WELL API NO. 30-015-01219
5. Indicate Type of Lease STATE <input checked="" type="checkbox"/> FEE <input type="checkbox"/>
6. State Oil & Gas Lease No.
7. Lease Name or Unit Agreement Name South Red Lake Unit II
8. Well Number #21
9. OGRID Number 241598
10. Pool name or Wildcat Redlake, Queen, Grybg, SA

SUNDRY NOTICES AND REPORTS ON WELLS
 (DO NOT USE THIS FORM FOR PROPOSALS TO DRILL OR TO DEEPEN OR PLUG BACK TO A DIFFERENT RESERVOIR. USE "APPLICATION FOR PERMIT" (FORM C-101) FOR SUCH PROPOSALS)

P&A Proposed Operations - work to be completed by 8-1-07

Stipulations for P/A Procedure
South Red Lake Unit II #21

Proposed

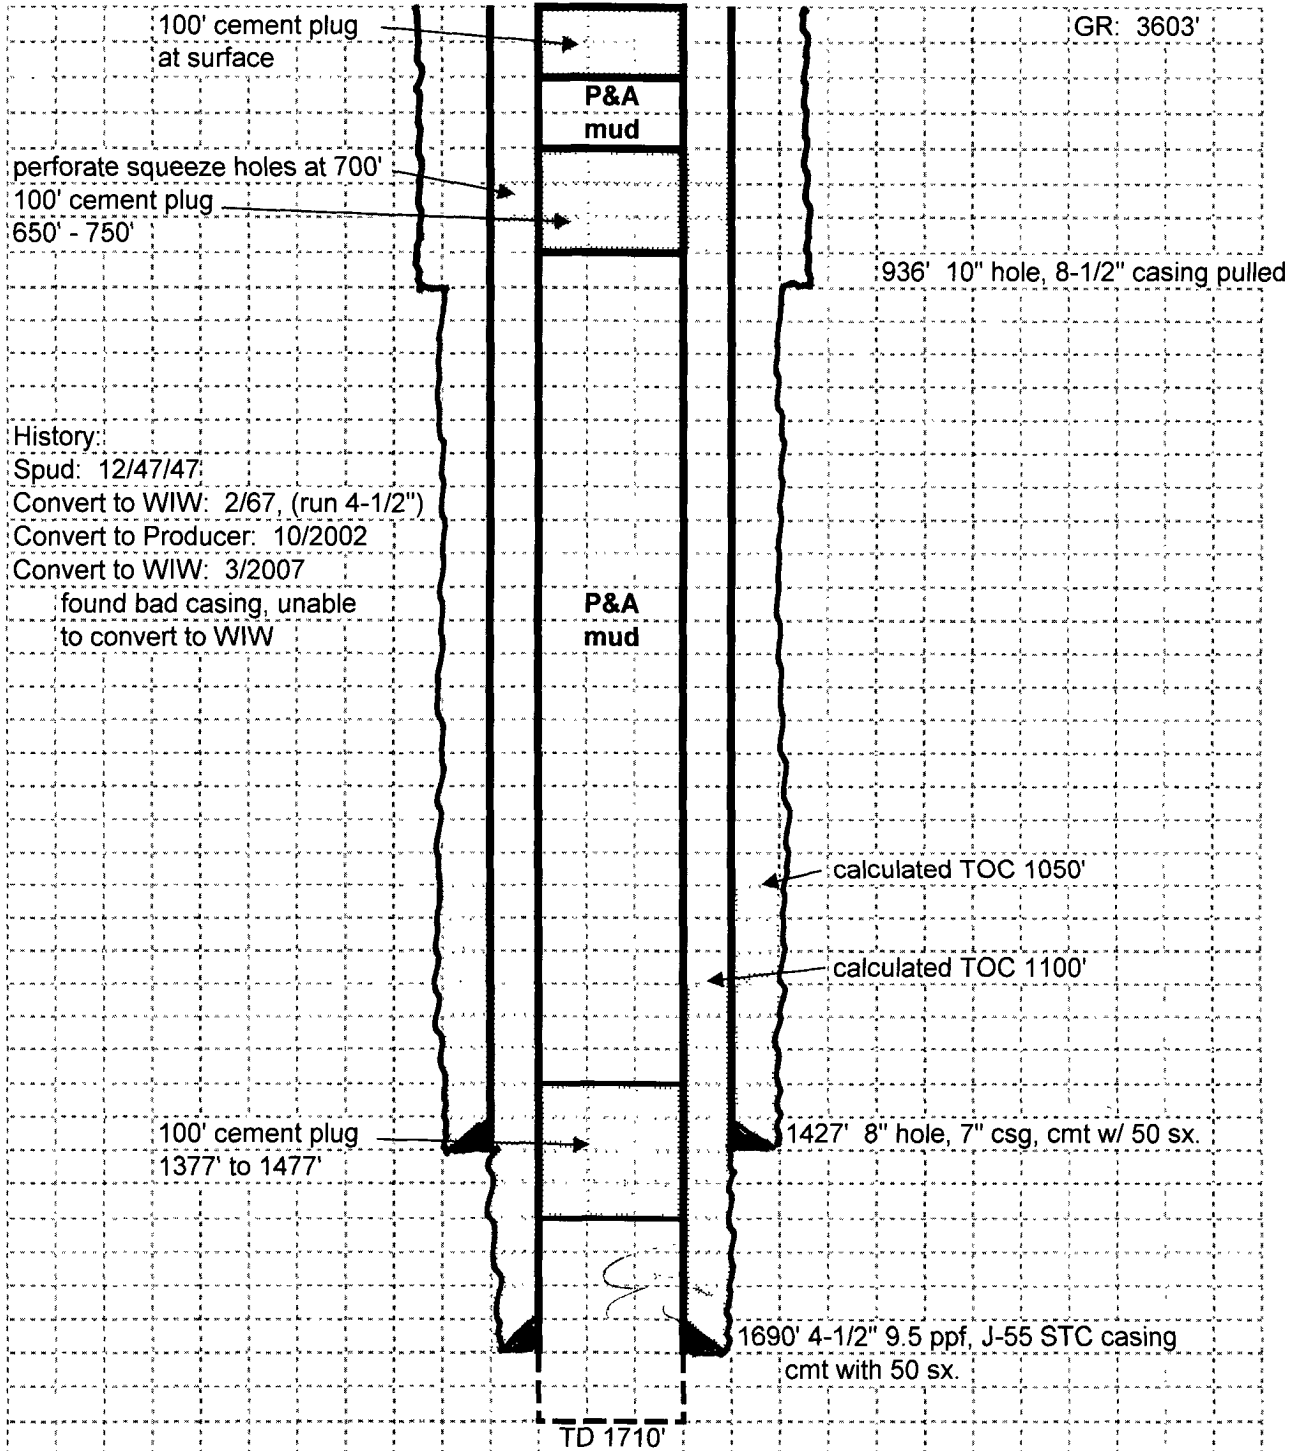
1. Plug proposed at 700' must be moved to 986' and perforations must include both strings of casing (4 ½" and 7").
2. Surface plug must be perforated (both strings) and circulated to surface.
